ADDENDUM 4

Contract: 24-C-00032; TPD Howard Avenue Annex Building

Item 2 – Add attached STRUCTURAL ASSESMENT INSPECTION & EVALUATION REPORT

## STRUCTURAL ASSESMENT INSPECTION & EVALUATION REPORT

**Photo 13:** Typical slab on grade cracks

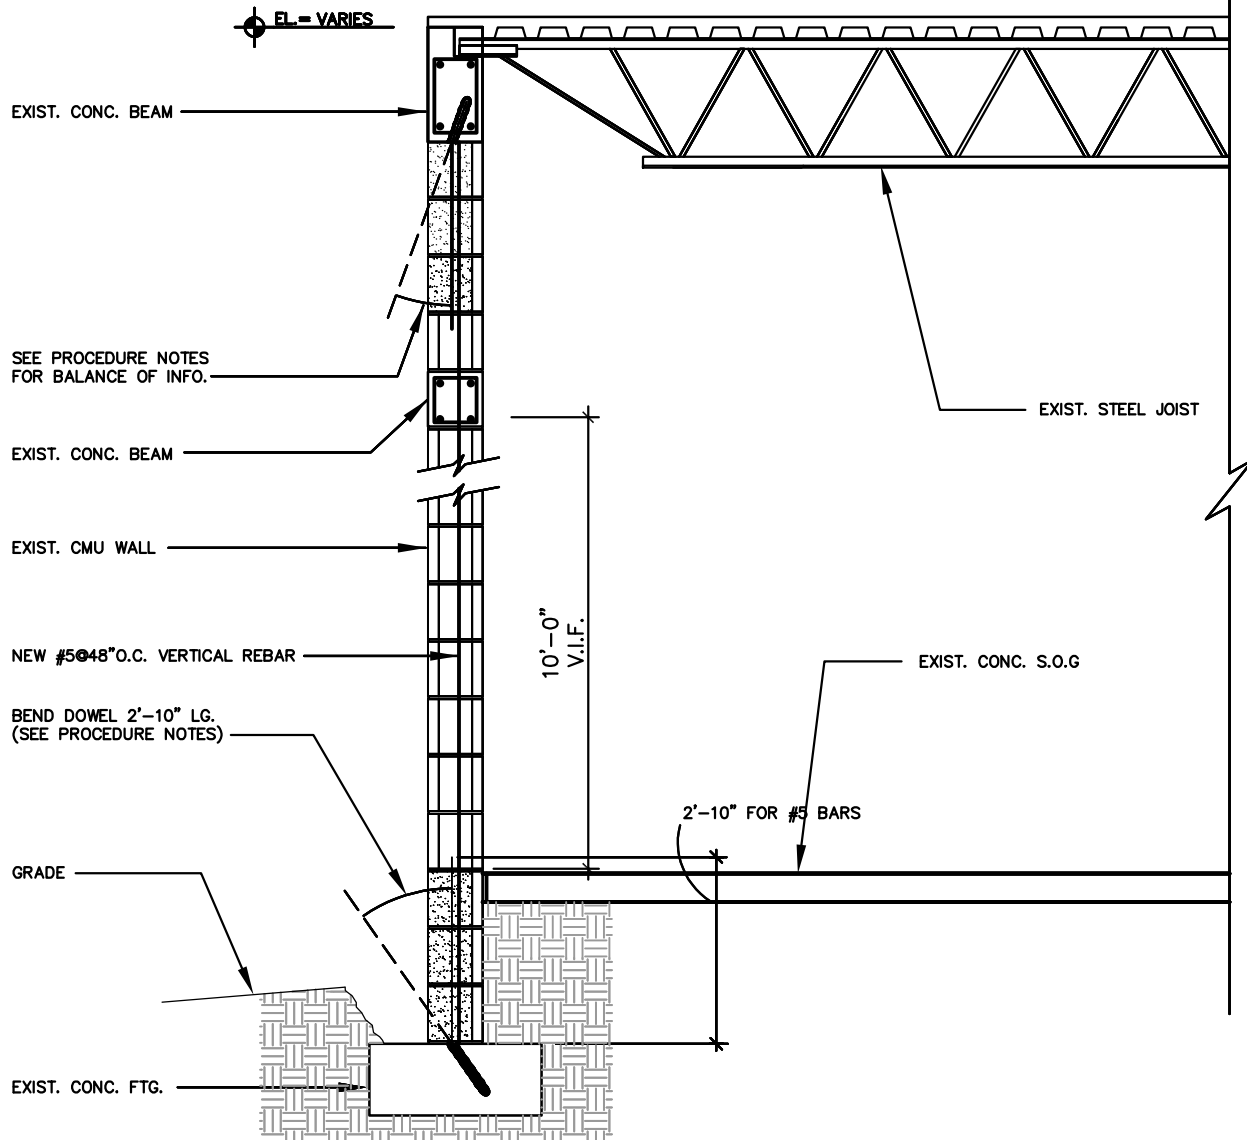
- Cracks observed on interior and exterior slab on grade at a few locations.
- Masonry wall penetrations at some locations.
- Spalling on exterior slab stairs handrail support at loading dock access.
- Rust found at roof deck to tie beam connections.
- Moisture accumulation on exterior masonry walls at several areas.
- Observed loose bolts at exterior W beam to concrete column connection.

Recommendations: The above observations may not represent a significant risk to the structure, but it is our recommendation provide cleaning and remedial procedures. (See appendix B)

SHEET NO. SSK-001

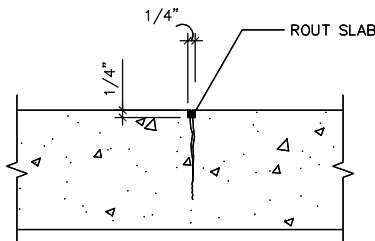
- Roof joists require to be provided with horizontal bridging at first panel point bottom chord as specify by the SJI.
- Exterior masonry walls as shown on Appendix "D" required to be reinforced with vertical #5 rebar at 48" O.C. See SSK-001 (Appendix "B")
- Recommend interior slab on grade crack repairs. See SSK-002 (Appendix "B").

## STRENGTHENING WALL DETAIL

### PROCEDURE NOTES FOR SECTION W2:

1. DIG EXTERIOR OF BUILDING TO EXPOSE EXISTING FOUNDATION.
2. LAYOUT THE ADDED BARS LOCATION AS SHOWN ON PLAN
3. BREAK THE EXTERIOR FACE OF CMU WALL TO INSTALL DOWEL (REBAR). DRILL & EPOXY DOWEL (REBAR) INTO EXISTING FOOTING (8" MIN. EMBED.) BEND BAR INTO THE CELL SPACING. (REPEAT PROCEDURE ON THE TOP UNDER TIE BEAM.
4. ON TOP OF THE WALL BREAK EXTERIOR FACE OF CMU WALL AS NEEDED TO INSTALL THE NEW ADDED VERTICAL REBAR.
5. FORM ALL OPENINGS DONE TO THE EXTERIOR WALL UP TO THE TOP ONE UNDER THE TIE BEAM. FILL CELLS WITH 3000 PSI CONCRETE.
6. AFTER CONCRETE REACH 75% OF ITS DESIGN STRENGTH, DRY PACK THE TOP CELL WITH NON-SHRINKAGE, NON-METALIC GROUT WITH A MINIMUM COMPRESSIVE STRENGTH OF 5000 PSI.

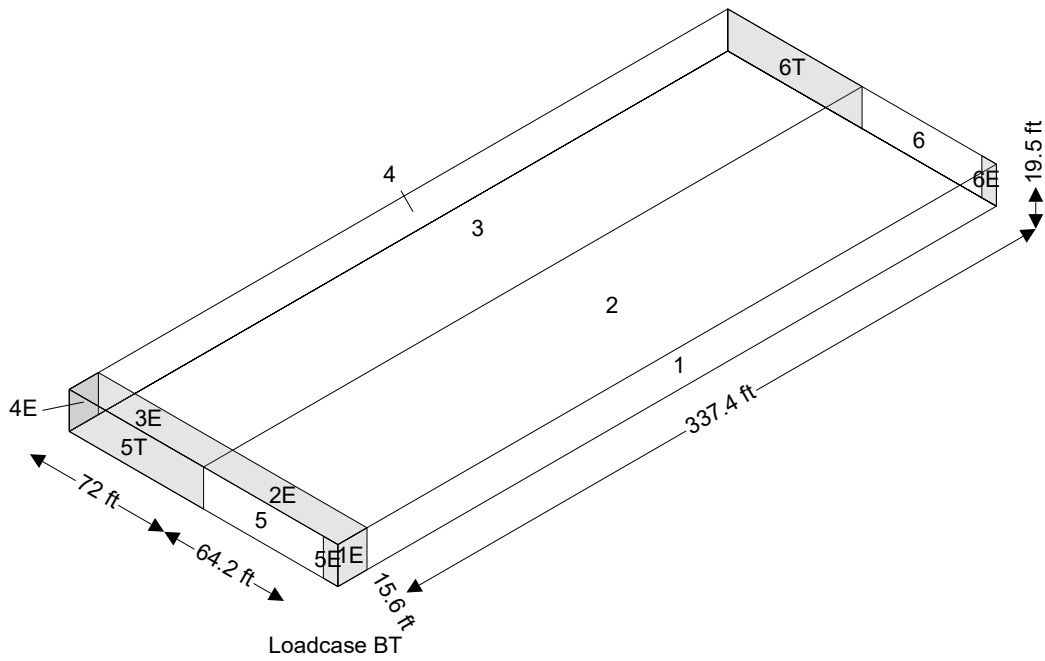
Masonry wall were analyzed as bearing walls, and frame shear walls to resist lateral loads from diaphragm and were found to be sufficient to withstand forces and comply with minimum requirements. However, as a mean to transfer wind out of plane loads, some of the exterior walls were found insufficient to meet and resist wind out of plane loads in combination with sustained dead loads, due to no reinforcement used in block cells. Walls required to be reinforced with vertical #5 rebar at 48" O.C. Refer to appendix "D" for location of walls to be reinforced.

DENOTES MASONRY WALLS TO BE  
REINFORCED WITH #5 @ 48"O.C.
